9 October 2017

**INFORMAL REFERRAL COMMENTS – DA 090/M008/17 (APPIAN ID 2397)
244-246 UNLEY ROAD UNLEY**

Council	CITY OF UNLEY
Application Number	090/M008/17 (APPIAN ID 2397)
Type	MERIT
Applicant	CATCORP PTY LTD
Locality	244-246 UNLEY ROAD, UNLEY
Hundred	ADELAIDE
Planner	KARL WOEHLE

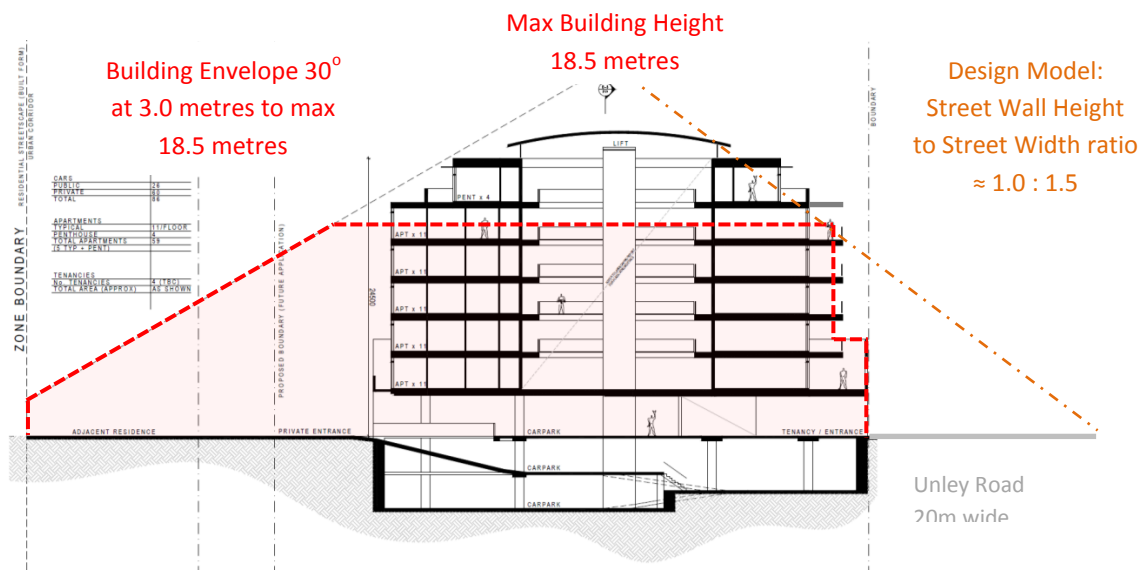
- The Street Wall height to Unley Road and Hart Avenue (desired 18.5 metres) is limited to around 20.0 metres with the top 7th storey further recessed from the edge to reduce dominance in perspective, albeit will still be apparent and dominate from adjacent outlooks and well beyond desired scale and bulk;

Hart Avenue (north) elevation

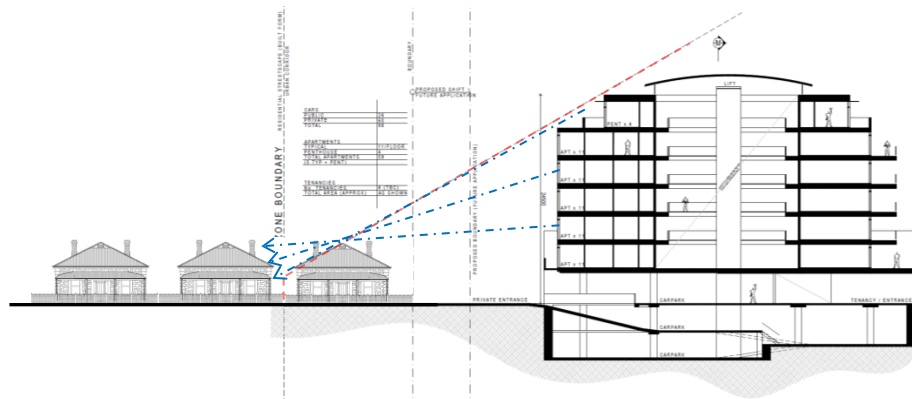
- The building emphasises a base podium façade, shop fronts and canopies to street frontages with recessed upper residential levels and open balcony and canopy features to articulate its mass. It is appreciated the treatment is contemporary and simple but more articulation and detailing could be provided to the parapet facades, pediments, individual shop fronts and particularly the canopies enlarged (longer and deeper with coordination with small building setbacks to create positive public spaces) to complement the desired and existing streetscape pattern;

Rear (west) elevation

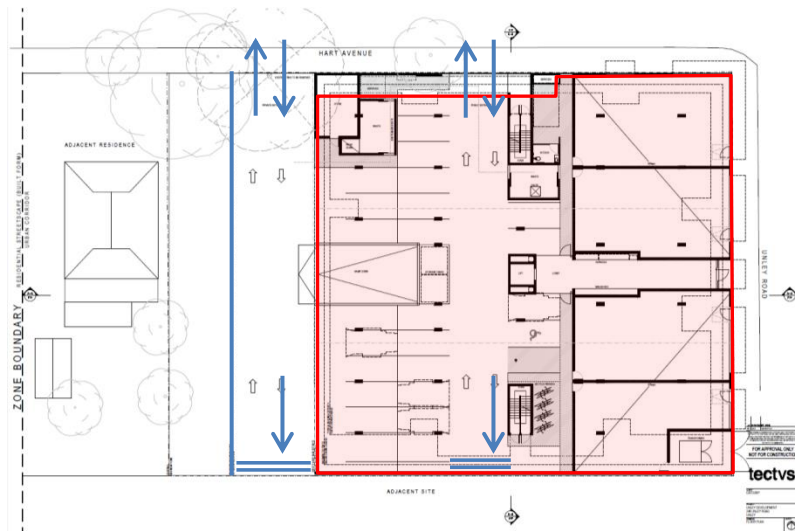
- Unreasonable open overlooking of adjacent residential private areas, particularly directly to the west and also obliquely to northwest and southwest, from rear and sides needs to be better addressed, ie by alternative orientation of outlooks, focus on long views, recessed viewing points, avoid reliance on variable effect vines, higher / wider / angled screening (eg obscure glass) to balconies and windows;

- The existing dwelling at 3 Hart Avenue, or alternative future development along the rear of the site, offers limited screening of downward views from higher levels into adjacent private residential areas;
- At the ground level 0.0 metre road and side boundary setbacks are acceptable, although up to 3.0 metre setbacks can be provided for outdoor dining. There should be a 2.0 metre setback provided from Hart Avenue west of 20.0 metres from Unley Road. This would provide relief to the narrow Hart Avenue and provide an opportunity for ground level landscaping;
